TULSA METROPOLITAN AREA PLANNING COMMISSION

For Meeting No. 2494

October 3, 2007

DATE PREPARED: SEPTEMBER 21, 2007
Exhibit "B"

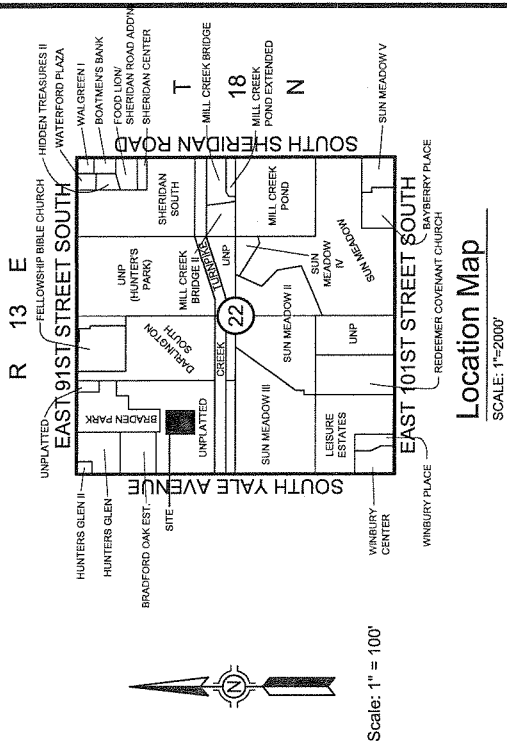
Fire: Alternative turnarounds may be a one hundred and twenty (120') feet hammerhead or a sixty feet (60') "Y". The 75' hammerhead is unacceptable. (*Concept Plan, Exhibit "B", modified per this comment.*)

Traffic: Maintain standard R/W 12ft behind the curb adjacent to L-3, BK-3. Delete the label "Street Main.(S.M.)" from the easement shown adjacent to both Public Streets and specify same on both sides of the Private Street. Specify Construction Standards for the Private Street within the PUD's Development Standards. Include language for the Maintenance of the small Private Street.

DETAIL SITE PLAN

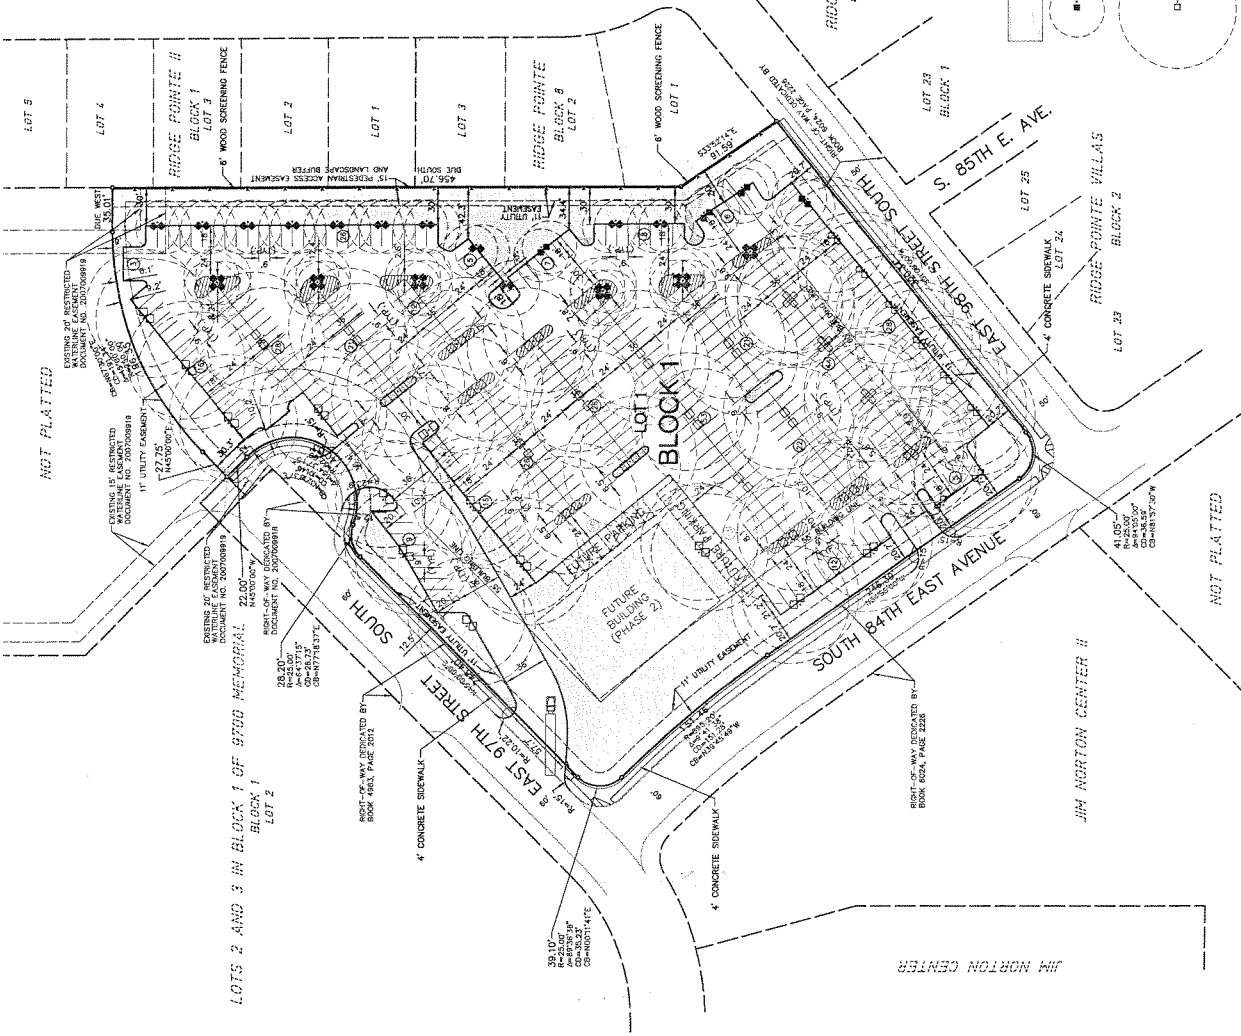
The proposed site complies with setbacks, minimum landscaped area and provides the minimum 15 foot landscaped buffer (and trail easement) as required by development standards. Proposed lighting complies with development standards and the zoning code per application of the Kennebunkport Formula. Sidewalks along East 97th Street South, South 84th East Avenue and East 98th Street South are provided as required.

A six foot wood screening fence is proposed along the east boundary adjacent to residential single-family as required by development standards. (There is an existing eight foot masonry wall on the residential side of the common boundary. Because it is on private property it does not meet the screening requirements for the commercial property.)

Finding that the proposed site plan (revised to include parking notes) complies with development standards and the zoning code staff recommends **APPROVAL** of PUD 411-C dsp.

Spring Hill Farms
Tulsa County, Oklahoma

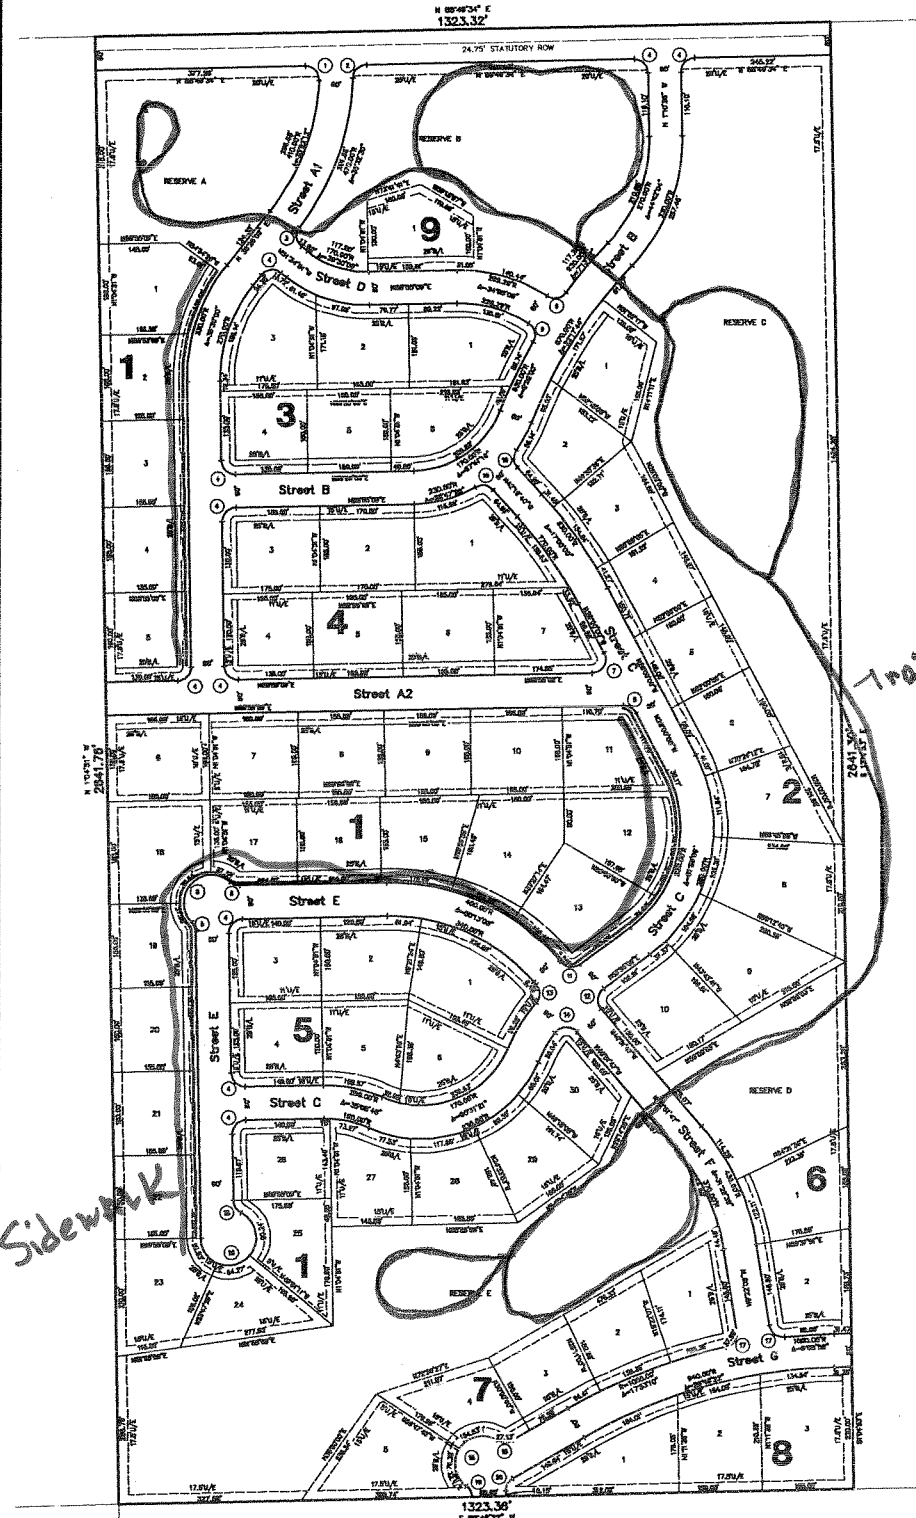
1. **Zoning:** The property is zoned PUD 745 (RS). All PUD conditions must be met. The County Commission has approved the PUD per a trails and sidewalk exhibit (attached) and with a collector street shown for future phases of development (map attached). Trails need to be per transportation planning standards.

2. **Streets:** Show limits of No Access restrictions along the Arterial. Discuss 4-legged intersection with County Engineer.
3. **Sewer:** Out of service area. Aerobic systems are proposed.

6. **Utilities: Telephone, Electric, Gas, Cable, Pipeline, Others:** This is outside of Cox Cable service area. Additional easements will be needed. Include ONG in covenant standard language. Clarify reserves versus utility

7. **Other: Fire:** Out of City. An appropriate Fire Department release will be required. **GIS:** Please provide the e-mail address for the surveyor. Tie the plat from a section corner using bearings and distances from a labeled point of commencement (POC) to a labeled point of beginning (POB). Give a basis of bearing for the plat's survey using degrees, minutes and seconds. **General:** Correctly name all streets. **County Engineer:** Show Limits of No Access along north boundary where appropriate. Street names and addresses will be assigned by E-911, to be placed on face of plat. Show "171st Street South" along north edge of plat. Show lot sizes in square footages. Provide driveway culvert sizes on lots or in a table. Restricted water line easement noted in covenants is not shown on plat. Need language to allow utilities in Reserve areas or utility easements across reserves. Change language to reflect public streets. Minimum front yard setback should read "from property line" or should be 55 feet from centerline of street. There are two Section III. Collector design and location to be approved by Tulsa County Engineer. Sidewalks will be needed to access trail system. May need access easements or extension of Reserves between lots to provide access to trails at appropriate locations, depending on sidewalk plan. Need drainage easements between lots 4 and 5, and 8 and 9, Block 2, and between lots 28 and 29, Block 1. Drainage easement locations may be a good place to combine access to trails, if needed.
